Scott Horsley
Water Resources Consultant
65 Little River Road · Cotuit, MA 02635 · 508-364-7818

April 22, 2022

RE: Weston 518 South Avenue Proposed Development

Figure 2 - Gaining Stream (USGS) showing groundwater discharging to the stream

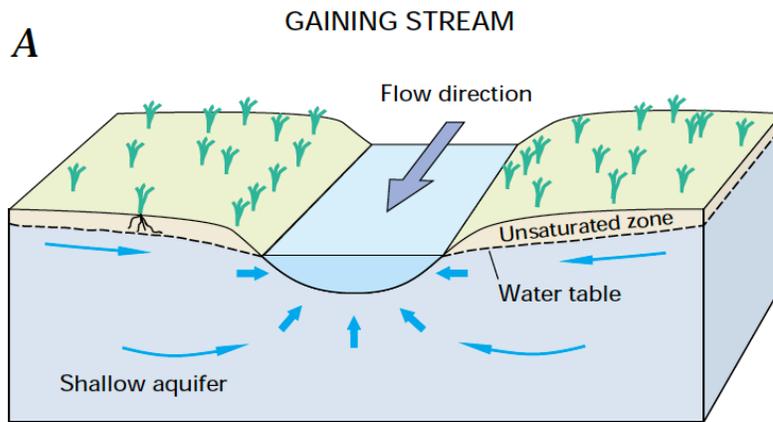
baseflow from groundwater discharging to them (see figure 2). This hydrologic connection between streams and surrounding groundwater is widely accepted.

Despite the widely accepted understanding of groundwater providing baseflow to streams, Ballestero states, “even when it is (flowing) the infiltrated wastewater is not flowing into the stream, but to groundwater that flows under and parallel to the stream” (emphasis added). He continues, “Some may ultimately show up in the stream, but not all”. This position suggests that the applicant has not yet developed an understanding of where groundwater is flowing and how it interacts with the adjacent wetland/stream, an alarming omission given the amount of field investigations and modeling that has occurred and the importance of this issue.
